Request for Proposals
For
Tynes Bay Waste to Energy Facility – The Sea Water Screening Plant -
Band Screen Replacement

ADDENDUM 2

Request for Proposals No.: **1512022**

Appendix A – Detail on Duplex Filters

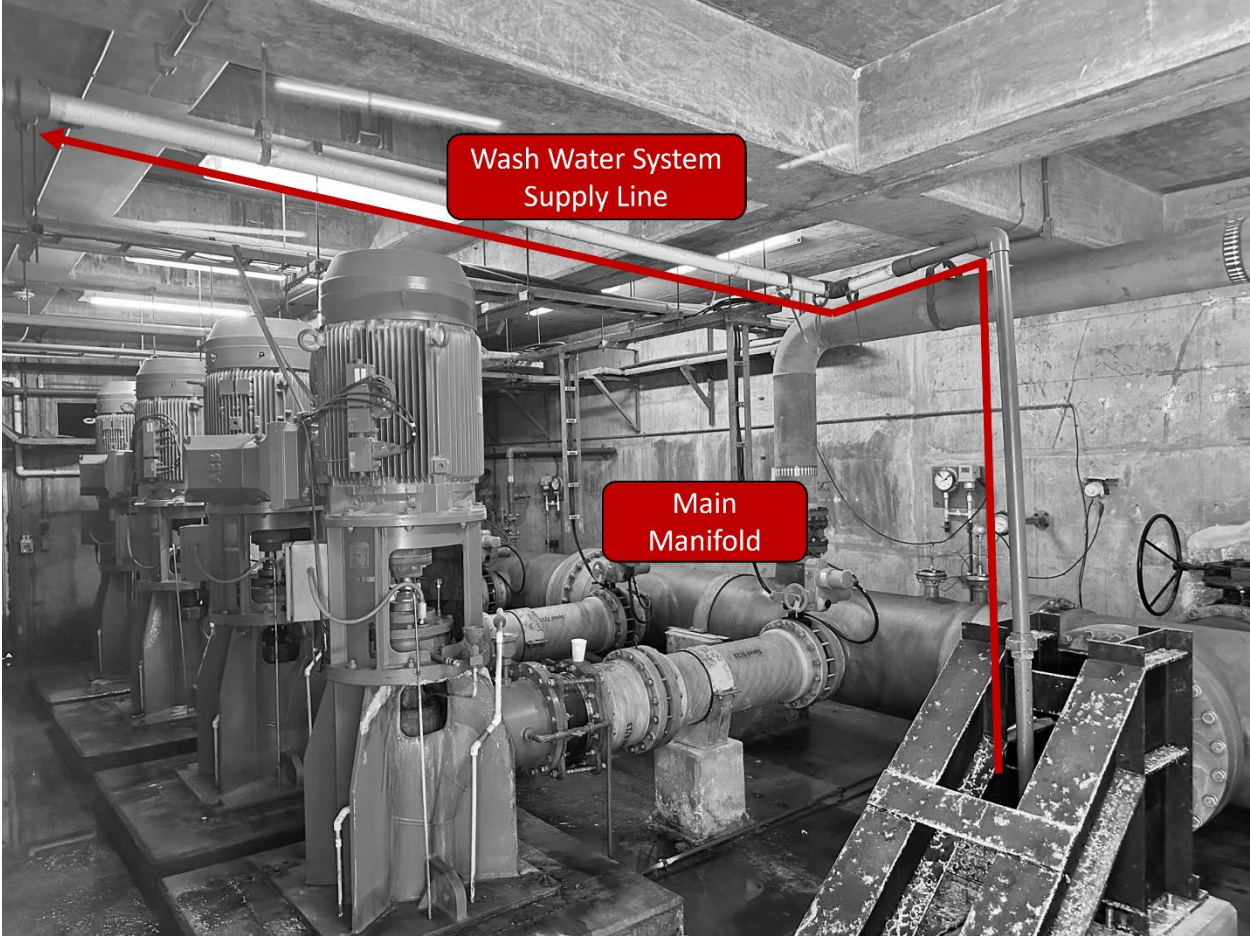
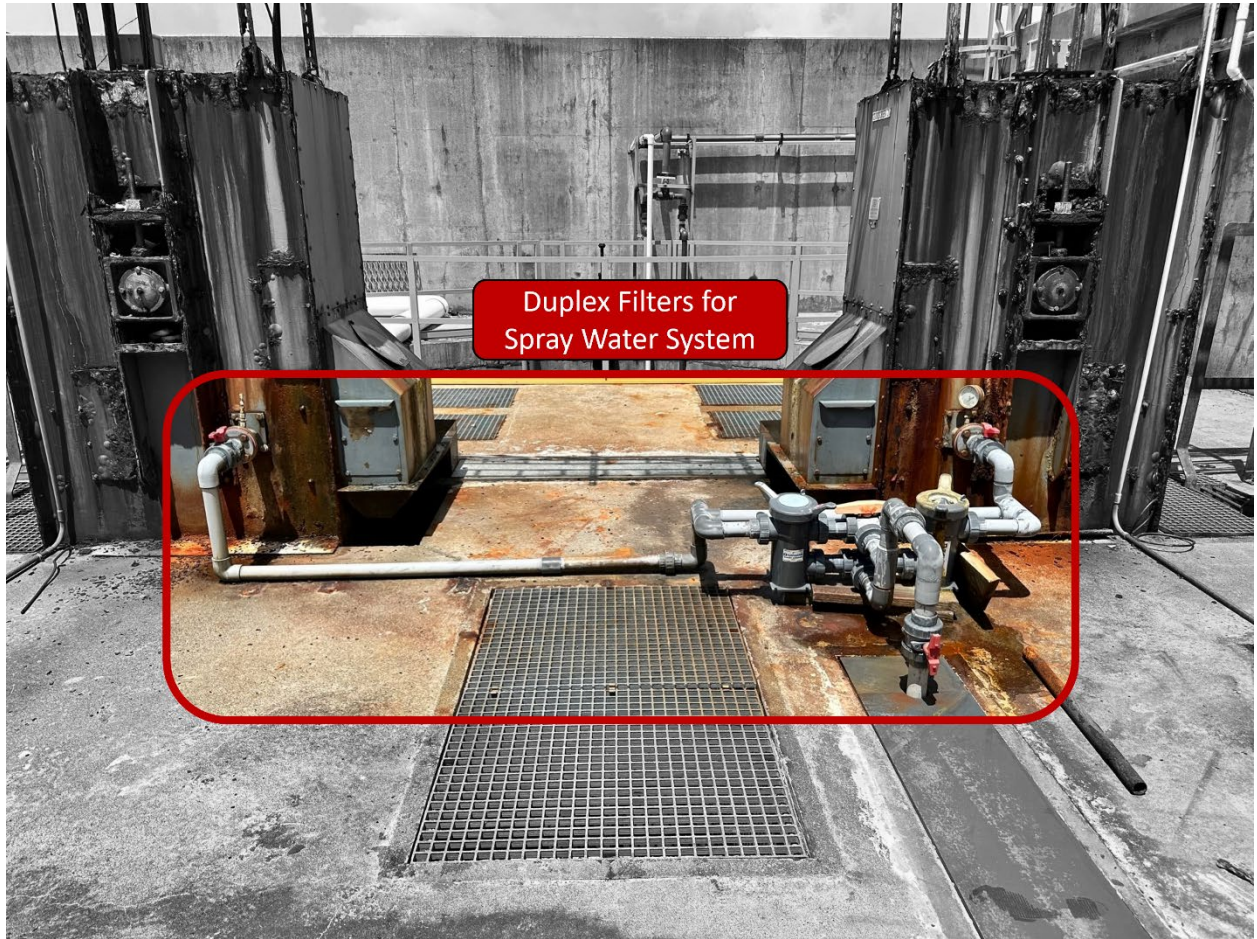
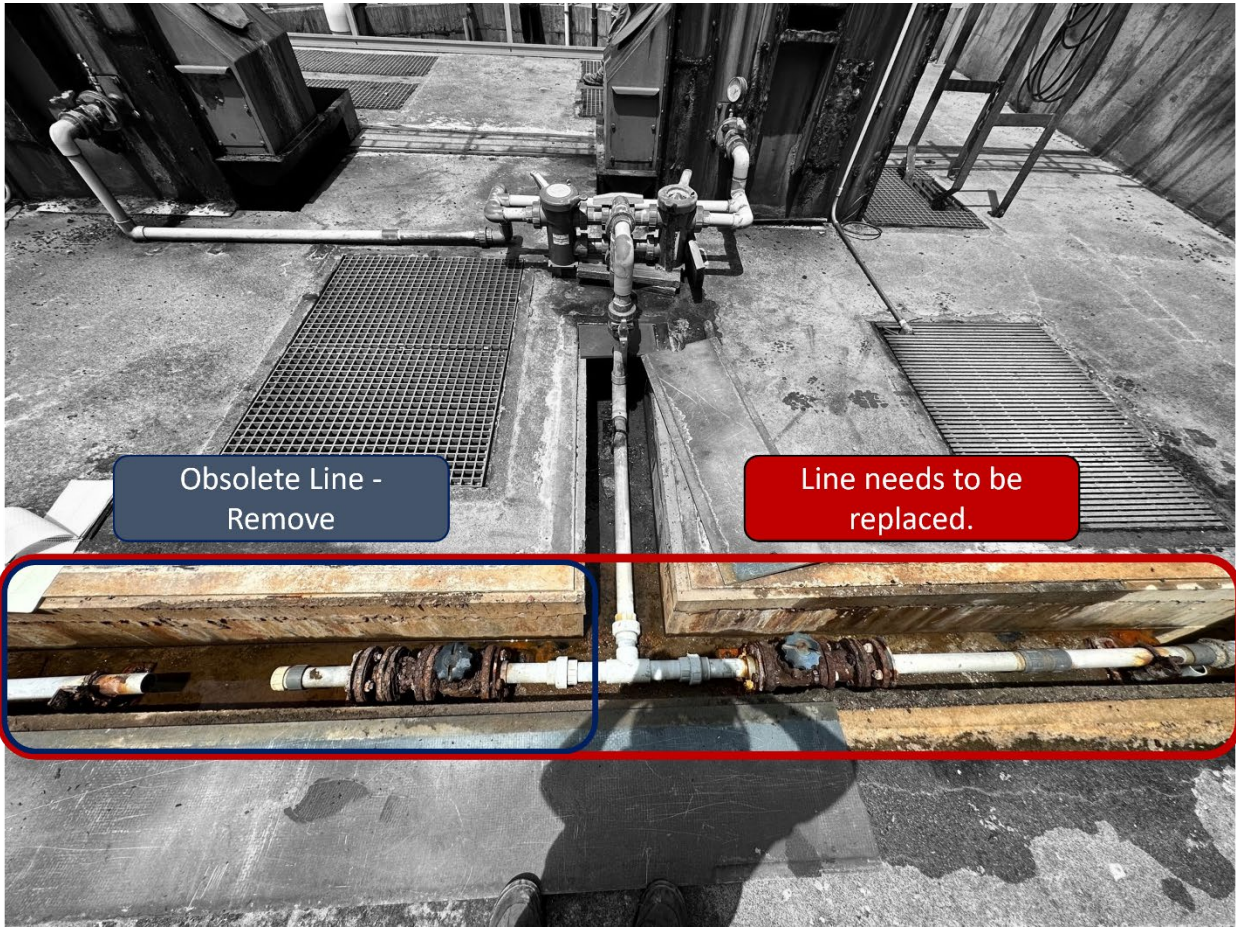
Clarification on Duplex filters and supporting pipework?

*There is currently a duplex filter inline upstream of the spray water wash system. The filters and pipework (shown in Appendix A) should be replaced. The duplex filters should be designed with manual control valves which allow each singular filter to be put into service and each filter can be isolated to change or clean the filter without isolating the entire spray wash system. **Pressure gages should be installed upstream and downstream of the filters with the scale appropriate for the pressure of the supply to the spray water system.** The water for the spray wash system is supplied from a line on the main manifold (shown in Appendix A) and has a separate line with a hose bib used for cleaning. These lines should also be replaced, and a hose bib put on the upper and lower levels. **Please install a hose reel with a heavy duty 100 ft hose and nozzle on the upper level.***

Obsolete Line -
Remove

Line needs to be
replaced.
